CITY OF WESTFIELD, IN
Advisory Planning Commission Meeting Agenda_07_20_2020

2003-DDP-04

Portillo's

Petition Number: 2003-DDP-04

SITE PLAN

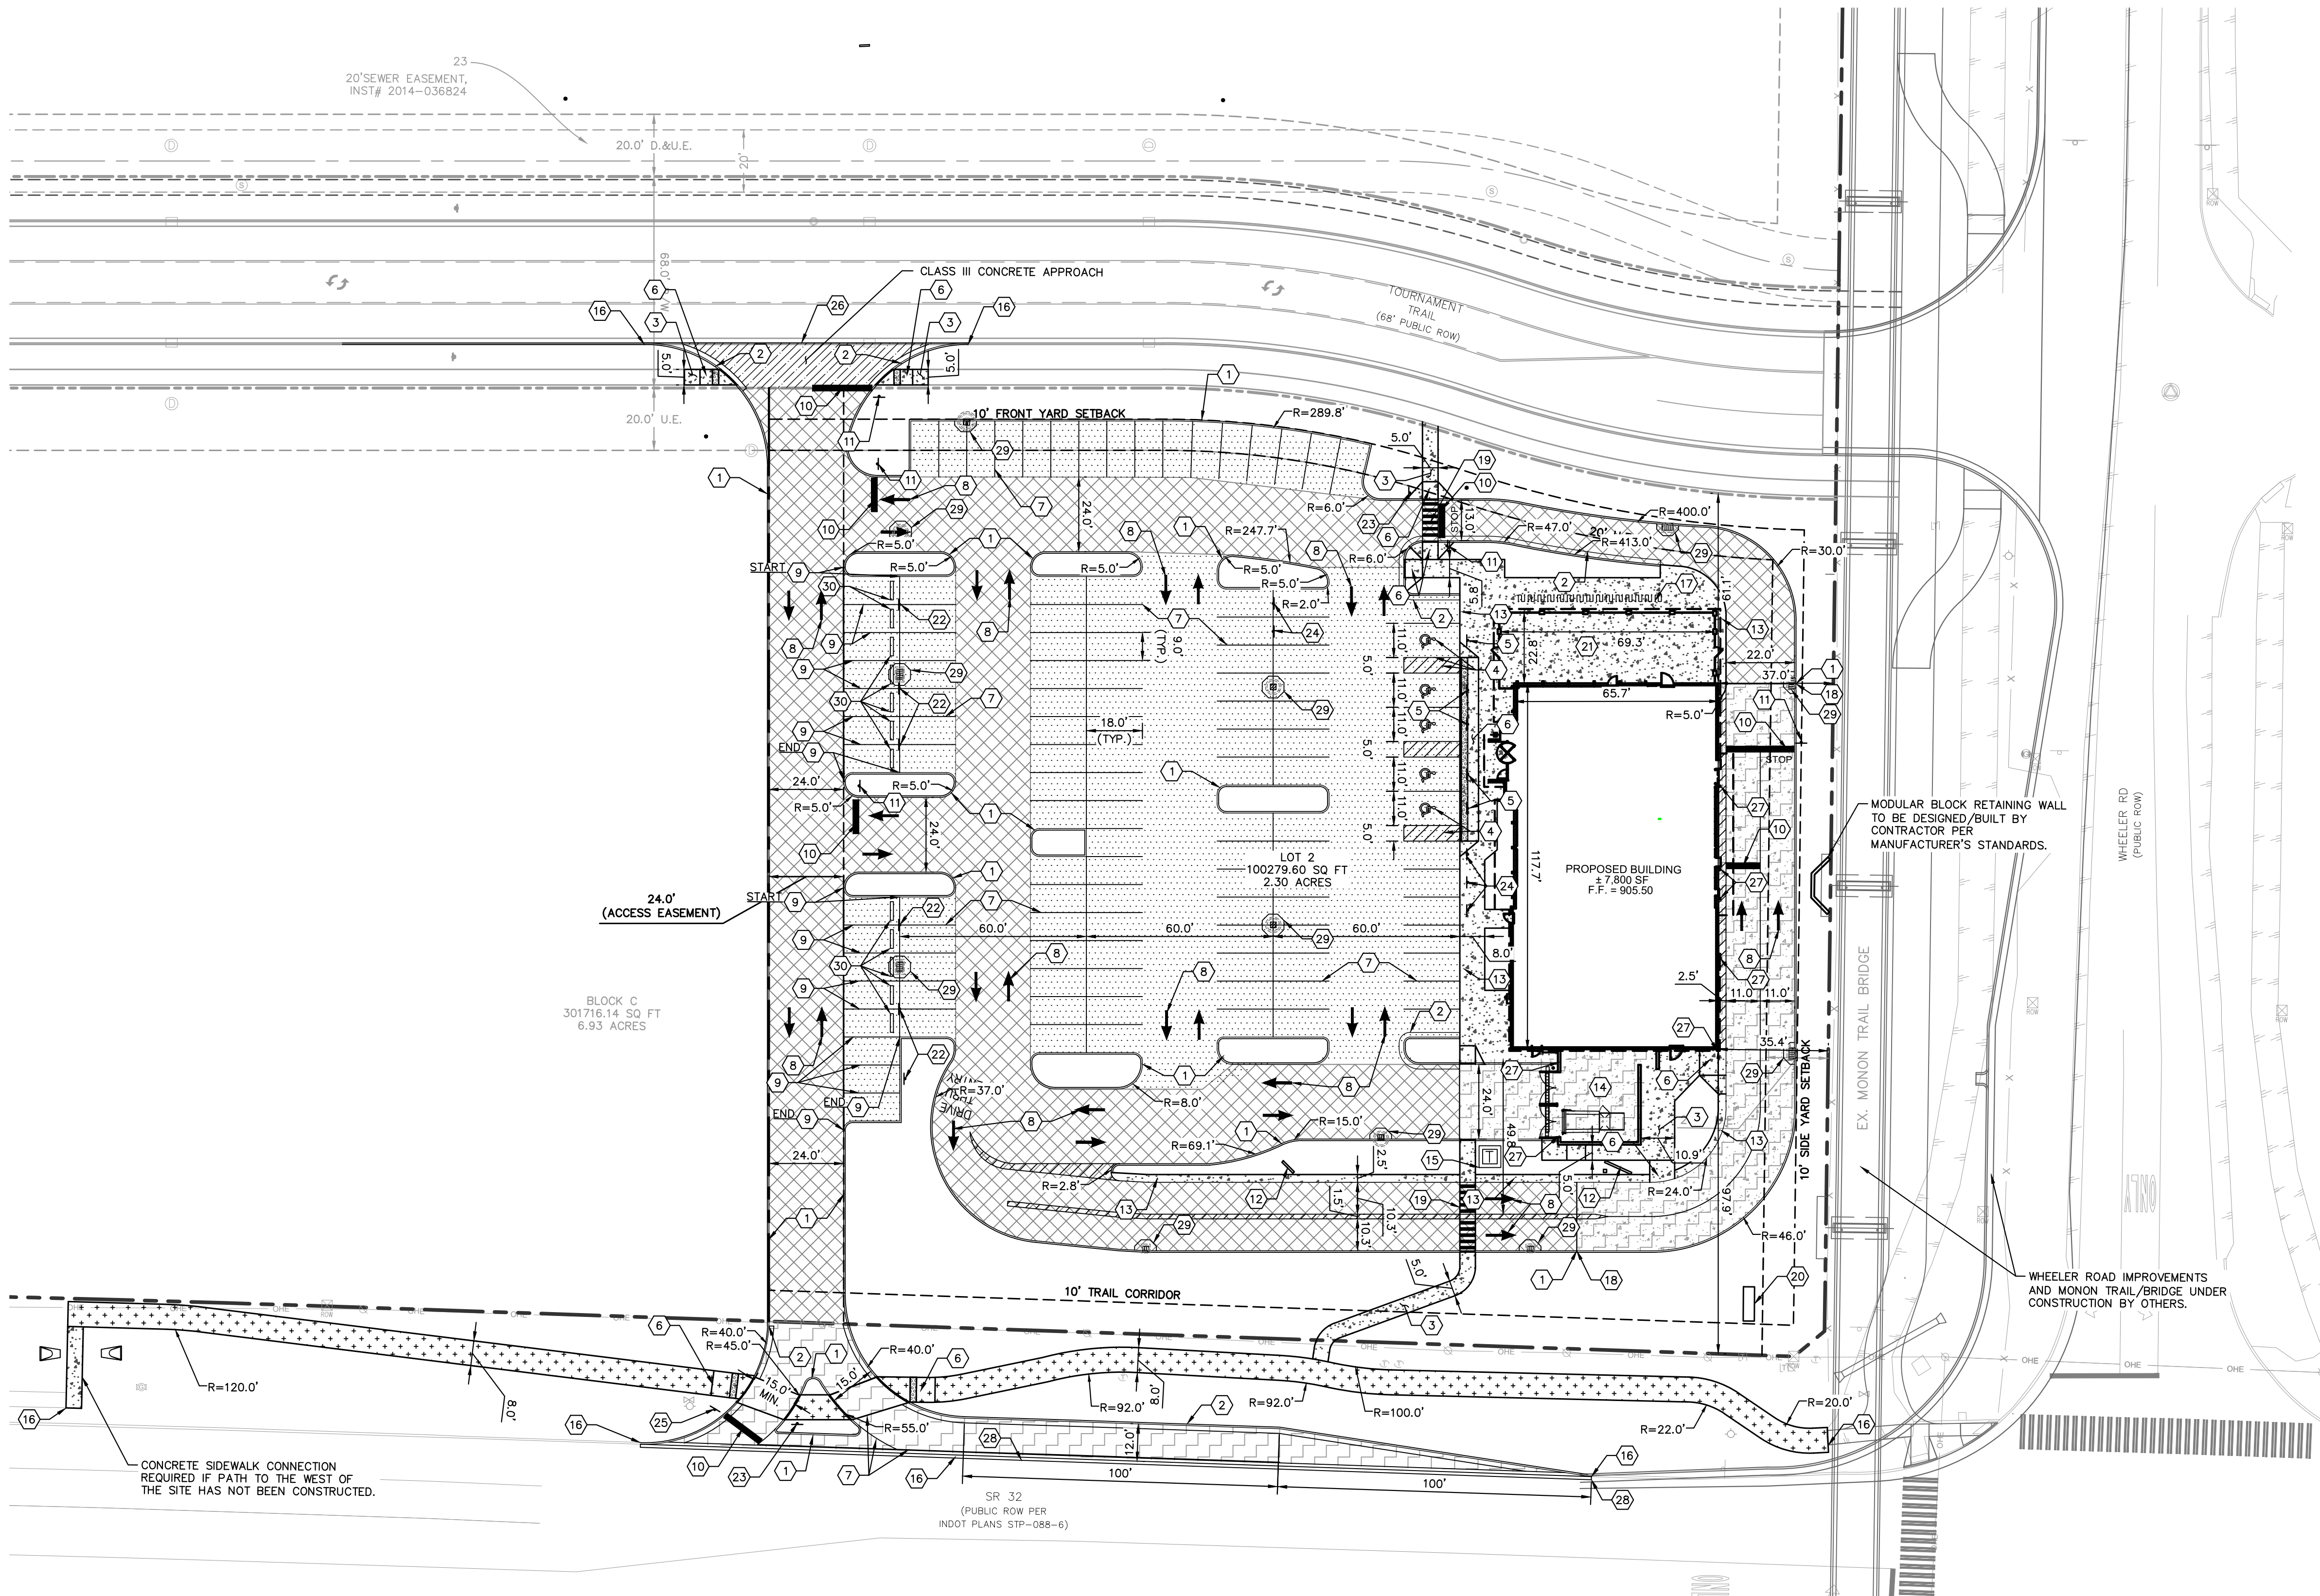
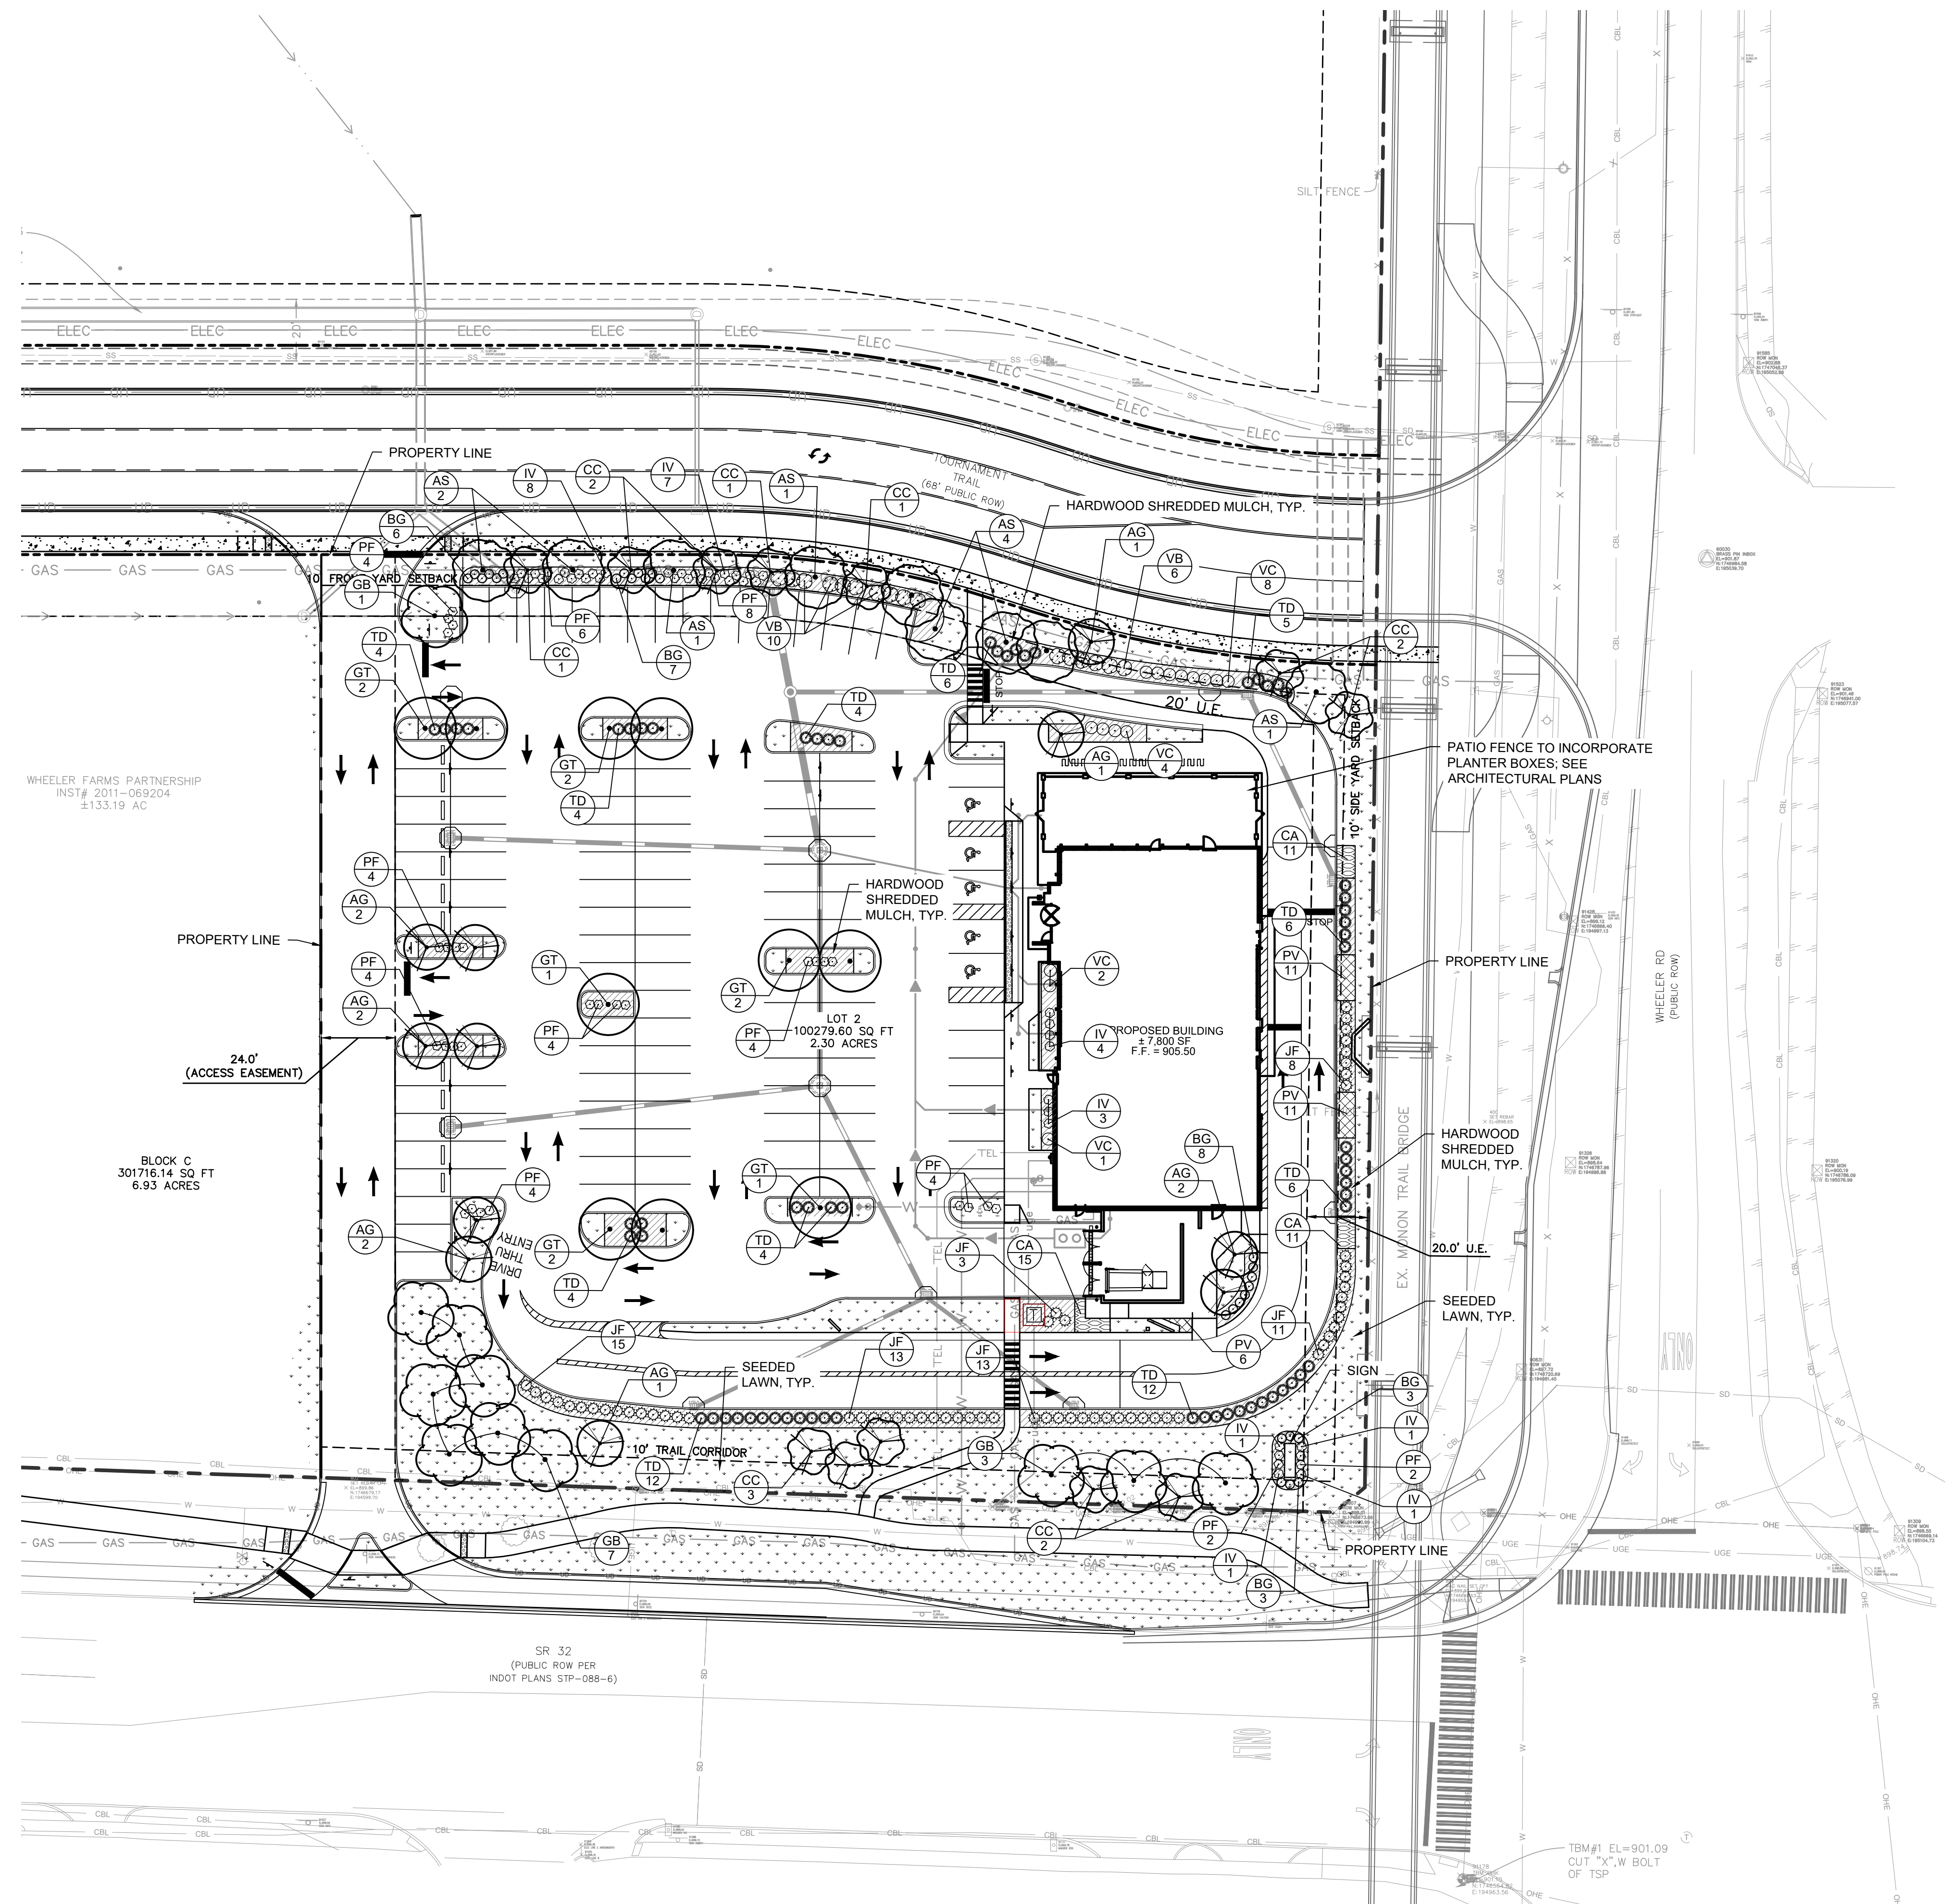
Spoljaric said that her original concerns related to building placement remain. She said she didn't think landscaping along SR 32 would adequately screen the parking area. She added that the types of trees to be used would not be in bloom year-round.

Schmitz stated his main concern was the south elevation and that he was pleased with the changes that were made. He said he was comfortable with the site layout given the explanations provided by Westfield Public Works and Portillo's. He said he was not worried about masonry compared to the overlay.

Johns said his biggest concern was the site layout; however, he would defer to the planners who stated that this is the best layout. He said he liked the masonry changes and the improved dumpster screening. He said he was pleased with stop bars that would be added to employee parking.

- 1) **The Detailed Development Plan complies with the applicable zoning ordinances.**
- 2) **ACTION: Approved Detailed Development Plan (2003-DDP-04) with the following condition:**
 - a. **All necessary approvals be obtained from the Westfield Public Works Department and Hamilton County Surveyor's Office prior to the issuance of an Improvement Location Permit.**
- 3) If any APC member has questions prior to the meeting, then please contact Caleb Ernest at 317.519.8630 or cernest@westfield.in.gov.
